## **Packet Guide**

BAR 21-05-01

503 Rugby Road, Tax Parcel 050052000

Project: Modify approved design – entry light fixtures; trim at sections of south and north facades; screening at mechanical units; fence/wall at NW corner.

STAIR TOWER REVISED DETAIL

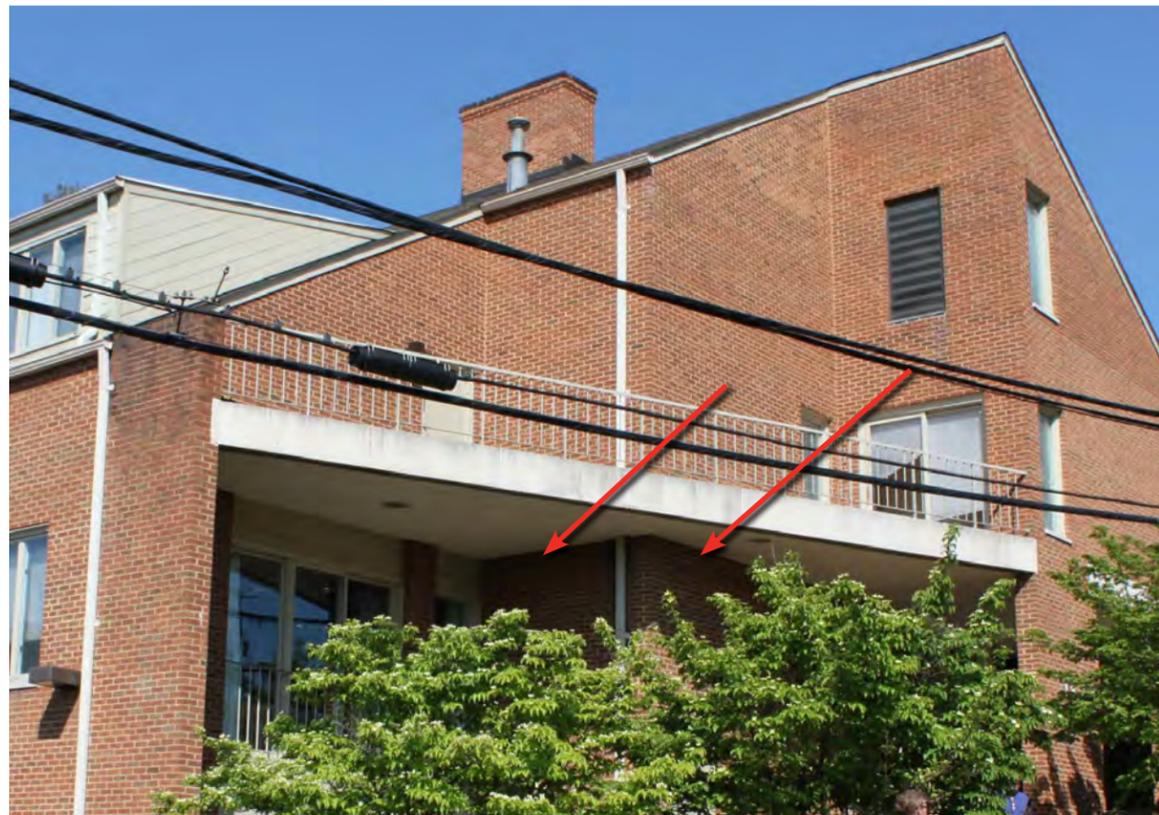
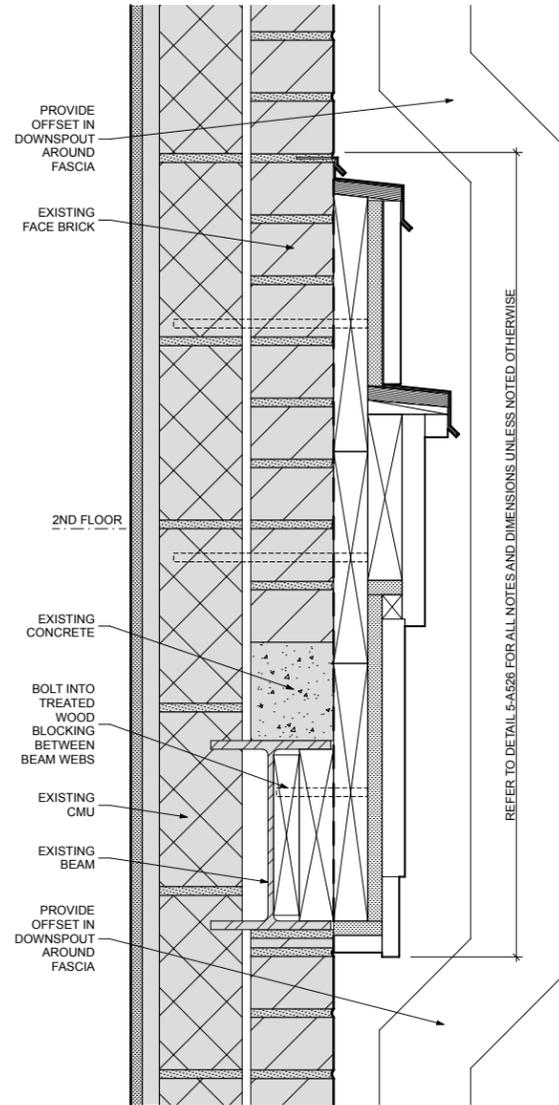
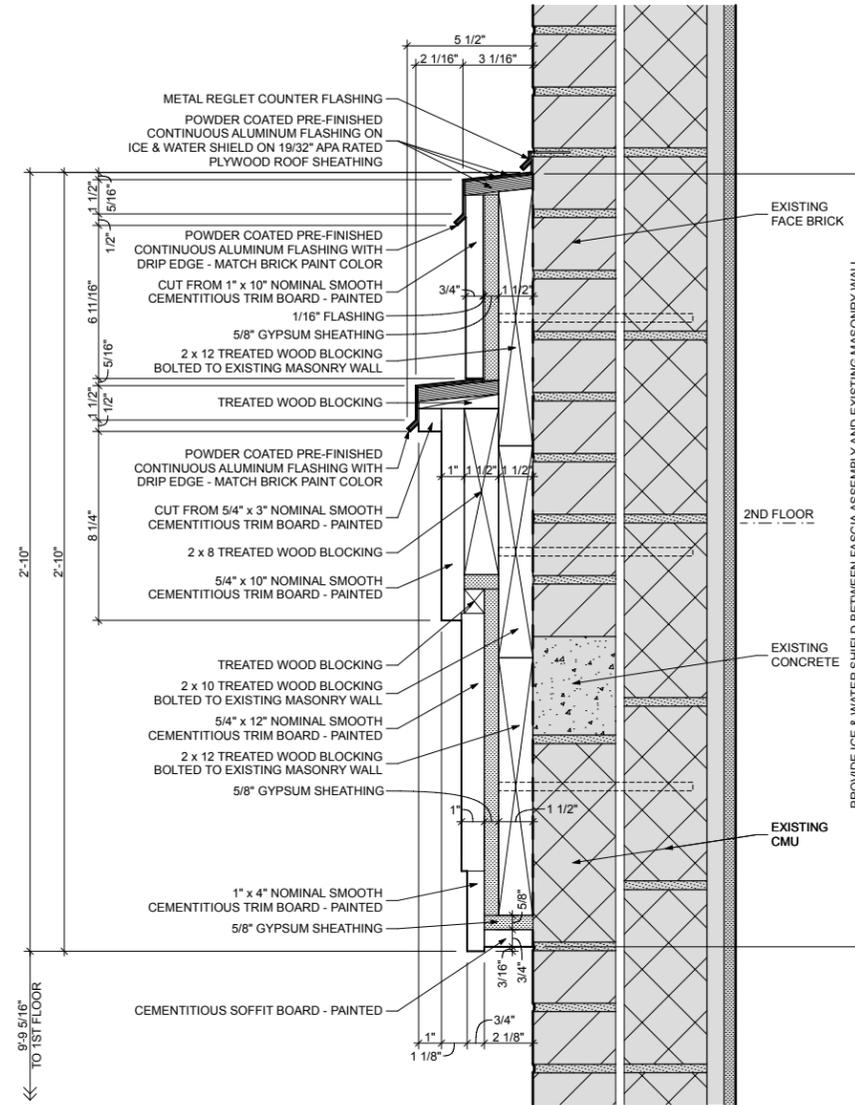
DURING THE COURSE OF DEMOLITION, FOLLOWING REMOVAL OF THE EXISTING BALCONY (SHOWN AT RIGHT) ON THE SOUTH FACADE, THE AS-BUILT CONDITION WAS DISCOVERED TO BE DIFFERENT THAN THE AS-BUILT CONSTRUCTION DOCUMENTS THAT WERE USED FOR THE BASIS OF DESIGN. AS A RESULT, A REVISED DETAIL MUST BE USED TO CONCEAL THE EXPOSED STEEL AND CUT EDGE OF CONCRETE BALCONY SLAB. REFER TO ELEVATIONS ON PREVIOUS PAGE, ABOVE, AND DETAILS ON NEXT PAGE FOR PROPOSED REVISION.

REVISED DETAILING TO MIMIC THE CONDITION AT THE NEARBY SOUTH ENTRY DOOR, REFER TO ENLARGED PARTIAL ELEVATION AND 3D MODEL VIEW BELOW.

REVISED DETAIL AT SIDE ENTRY ON EAST FACADE

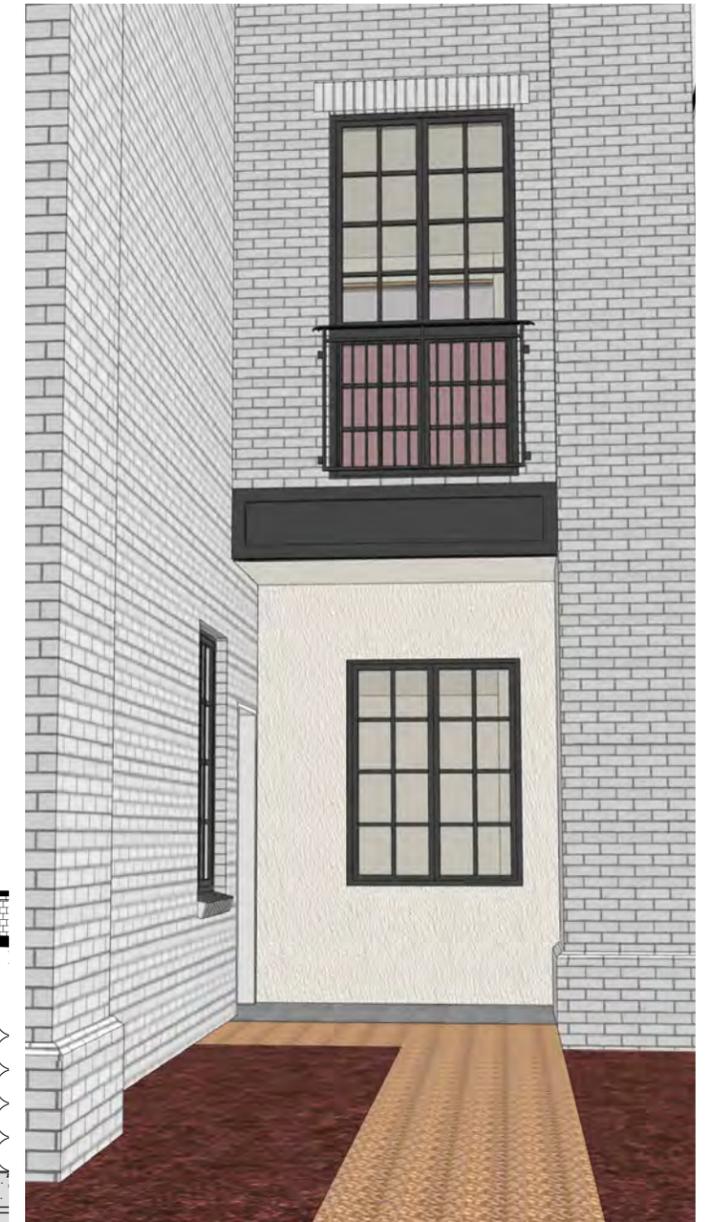
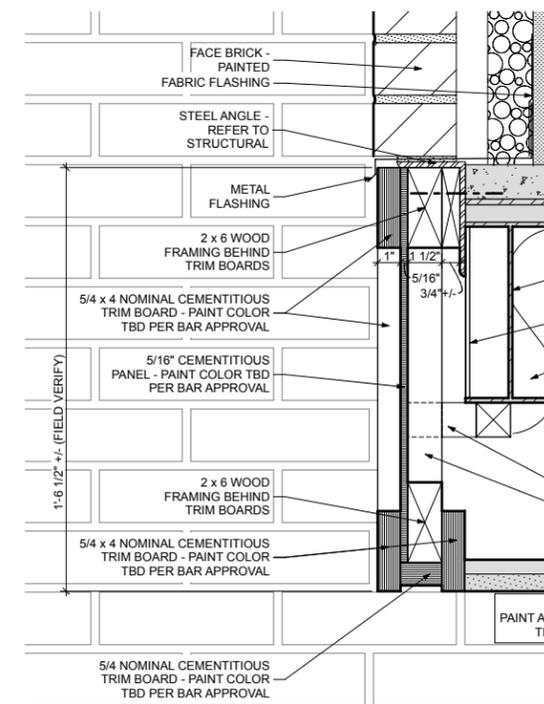
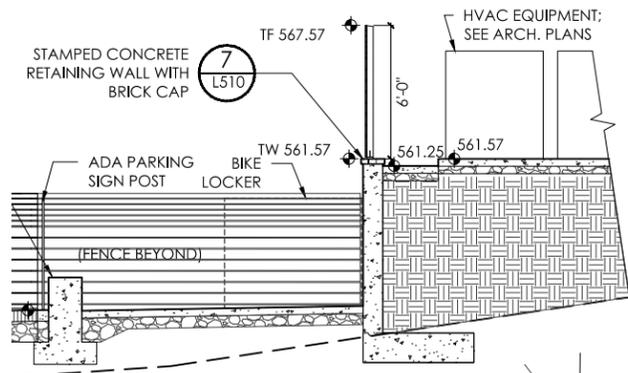
AN OVERZEALOUS DEMOLITION CREW MISTAKENLY REMOVED THE CAST STONE LINTEL PICTURED ABOVE, THAT WAS ORIGINALLY INTENDED TO REMAIN. (IT WOULD HAVE BEEN A UNIQUE CONDITION.) THE REVISED PROPOSED DETAIL IS A HARDIE BOARD PANEL WITH TRIM SIMILAR TO THAT USED ON THE SOUTH FACADE.
